**Response to the Notice of Disapproval for the
Investigation Report for Lower Sandia Canyon Aggregate Area,
Los Alamos National Laboratory, EPA ID No: NM0890010515, HWB-LANL-11-019,
Dated July 15, 2011**

Figure H-15 Box plot for arsenic in tuff at AOC 53-013

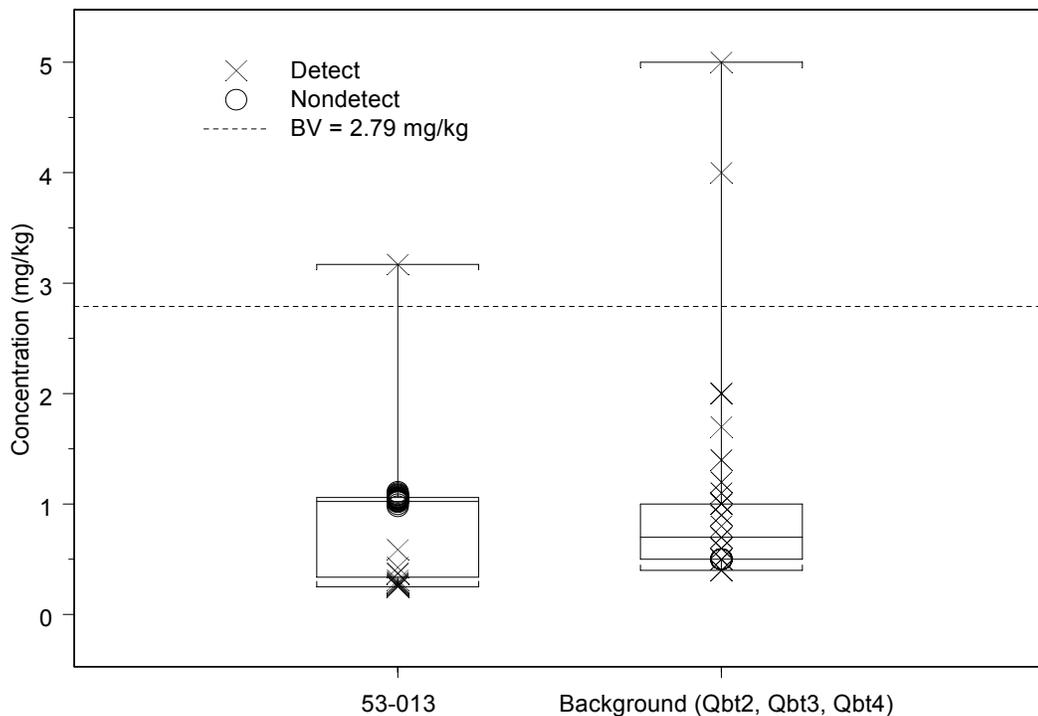
The text indicates that arsenic is not identified as a chemical of potential concern (COPC) at AOC 53-013 because it was detected above the Qbt 3 background value in one sample and the detected concentration was below the maximum Qbt 3 background concentration. However, the results of the quantile test indicated that concentrations of arsenic at AOC 53-013 are different from background. Arsenic must be retained as a COPC. The Permittees must revise the risk screening to include arsenic.

14. The Laboratory reviewed the original statistical comparison of the arsenic site data set with the arsenic Qbt 2, 3, 4 background data set using the quantile test and found the incorrect quantile had been evaluated. The original comparison looked at the 50th quantile, which resulted in a statistical difference, although the two data sets are not different as illustrated by the box plot (see below). In reevaluating the data sets and comparing the upper 80th quantile as is appropriate for the quantile test, the two data sets are not statistically different ($p = 0.87$). The slippage test also results in a p -value > 0.05 ($p = 1$) for these data sets. Therefore, arsenic is not a COPC for AOC 53-013. The text in section 7.13.4.3 and the statistical test results in Table H-10 in Appendix H have been revised accordingly. The discussion of extent of arsenic has been deleted from section 7.13.4.4 because arsenic is not a COPC for the site.
